**Topic:**

R50X stator defect

R50X model

Picture 1 : original stator cable without blue tape    Picture 2 : new stator cable with blue tape

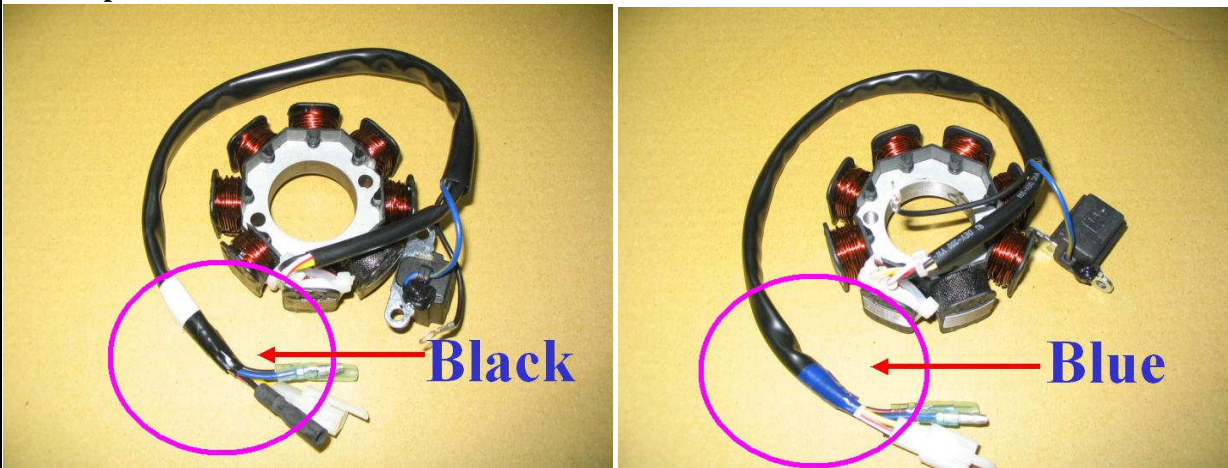
We received claims that while riding R50X, the engine would suddenly turn off and then could not start anymore due to stator problem.

1. Change stator supplier
2. To execute full inspection
3. Tape a blue tape at the end of stator cable to recognize as picture 2.
